**OLEARIA**  
TOWN PLANNING

**Council Reference: A005833983**

**RE: Request for a minor change to Development Permit for making a material change of use for an extension to a multiple dwelling**

**Site Plan DWG No. 002, Issue B**

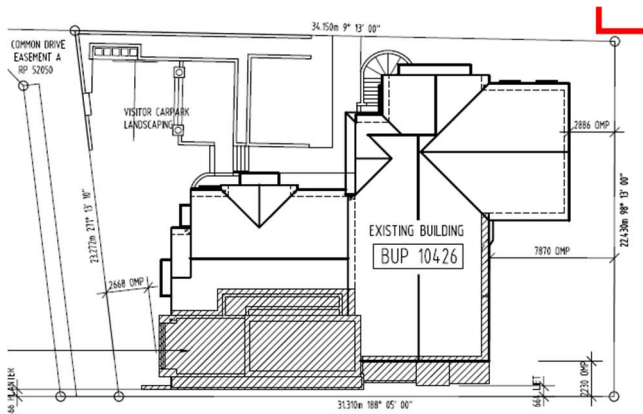
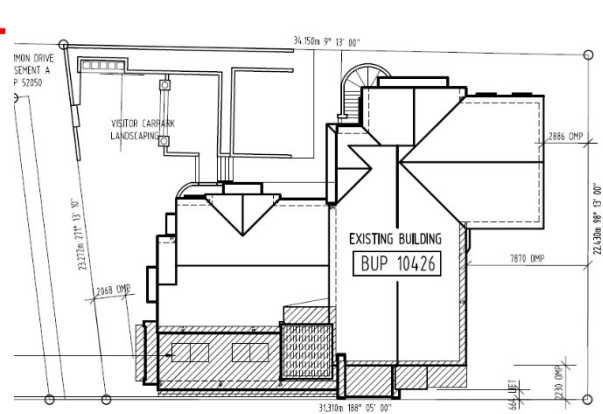
- Alterations to
- Reduction of setback to planter from 466mm to 200mm.

### Existing Sub Floor Plan DWG No. 003, Issue C

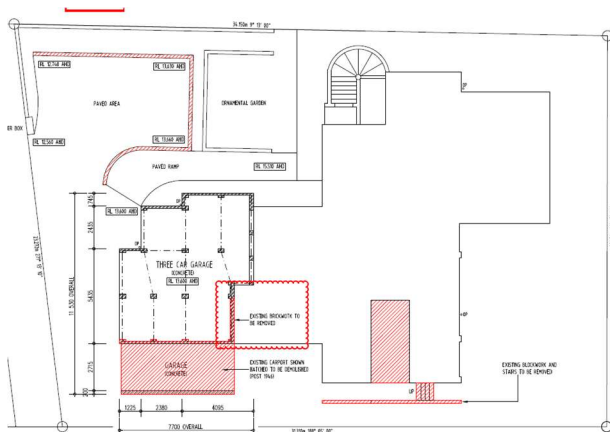
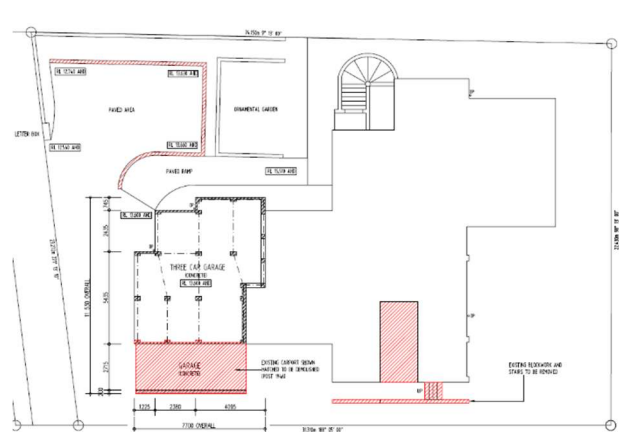
- Brickwork to rear of garage originally shown to be removed, now to be retained.

**Proposed Sub Floor Plan DWG No. 011, Issue F**

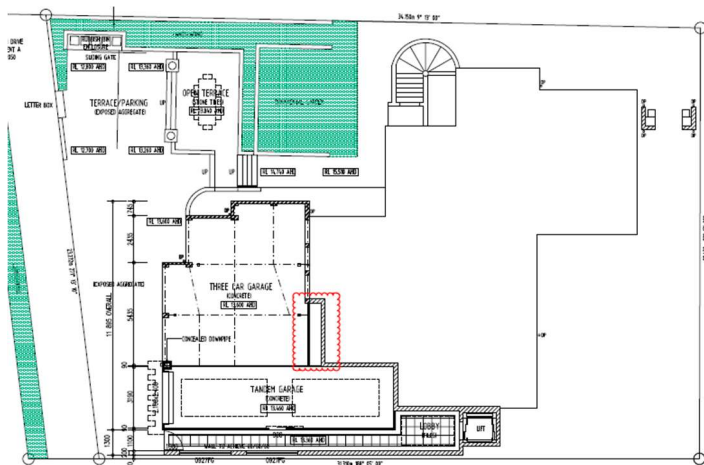
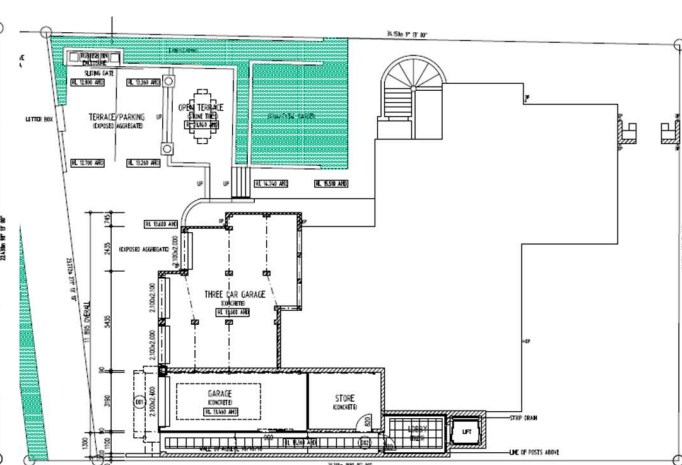
- Minor extension of footprint to garage no longer proposed.

**Proposed Lower Floor Plan DWG No. 012, Issue G**

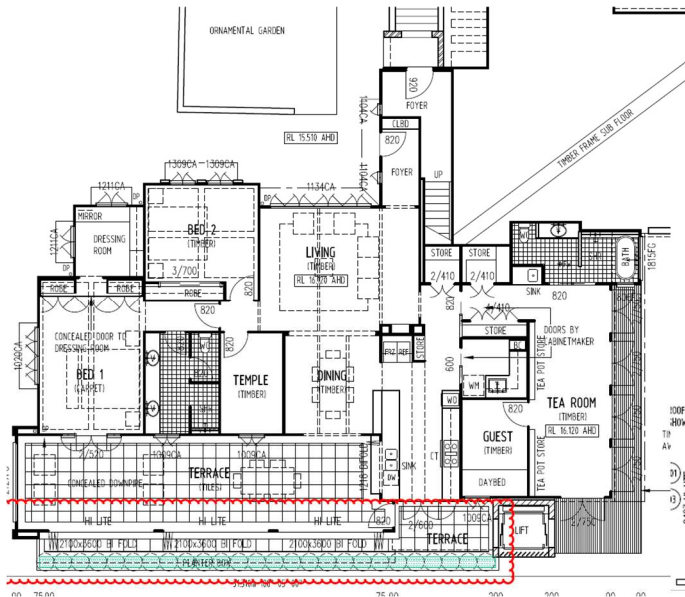
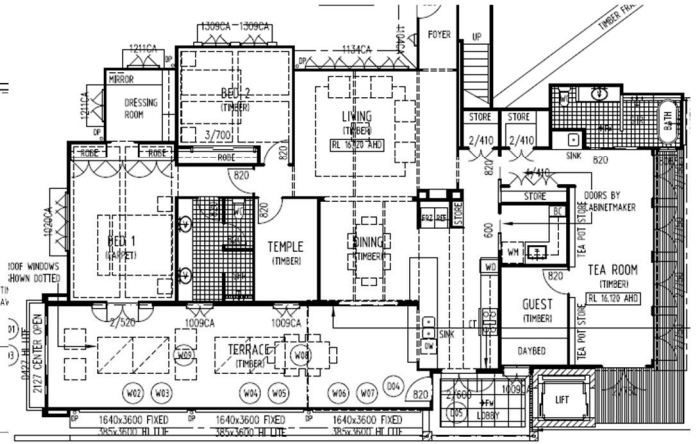
- "Terrace" outside lift, more appropriately renamed to "Lobby".
- Removal of planter box to side setback, and removal of bifold doors.

### Proposed Mid Floor Plan DWG No. 013, Issue H

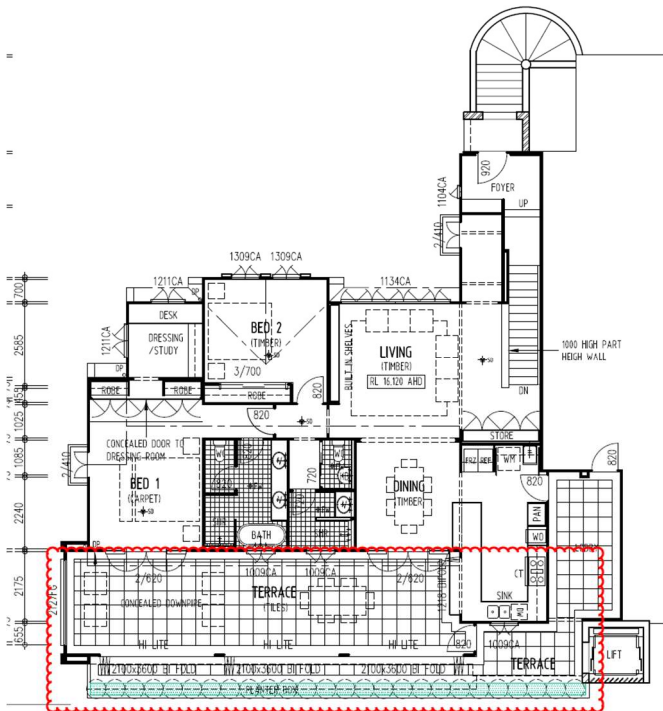
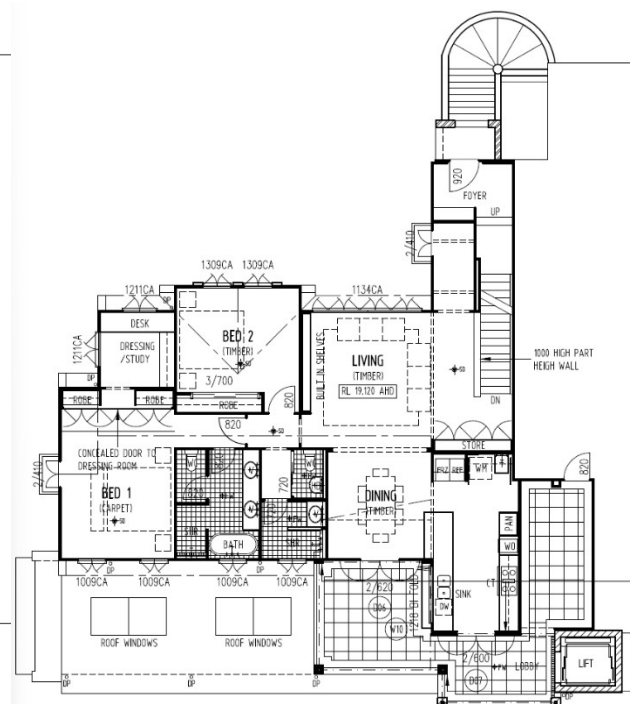
- "Terrace" outside lift, more appropriately renamed to "Lobby".
- Reduction of terrace area and introduction of roof with windows.
- Removal of planter box.

### Proposed Upper Floor Plan DWG No. 014, Issue K

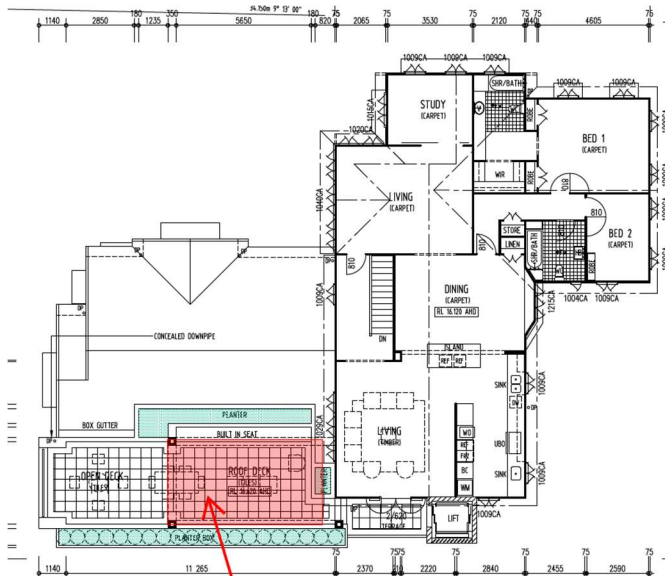
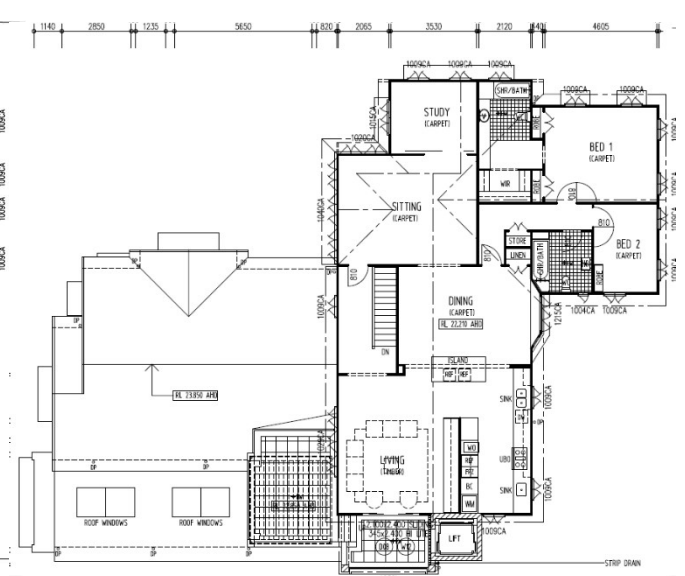
- "Terrace" outside lift, more appropriately renamed to "Lobby".
- Terrace entry made slightly wider to allow for improved accessibility to lift.
- Reduction of open deck and roof deck.
- Roof shown for terrace below.
- Removal of planter box.

### Proposed Roof Plan DWG No. 015, Issue H

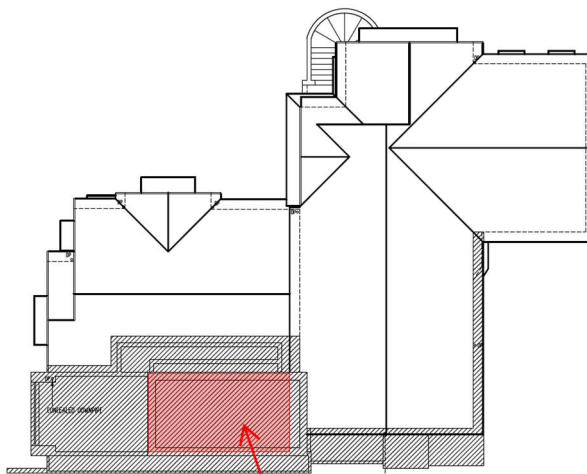
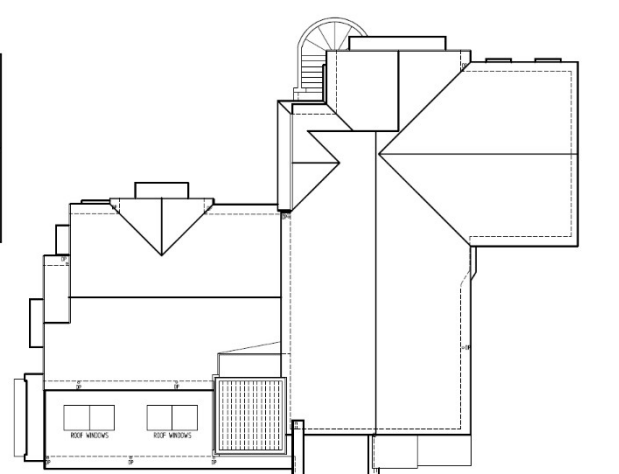
- Roof altered to reflect reduced terrace areas and increased lift lobby dimensions.
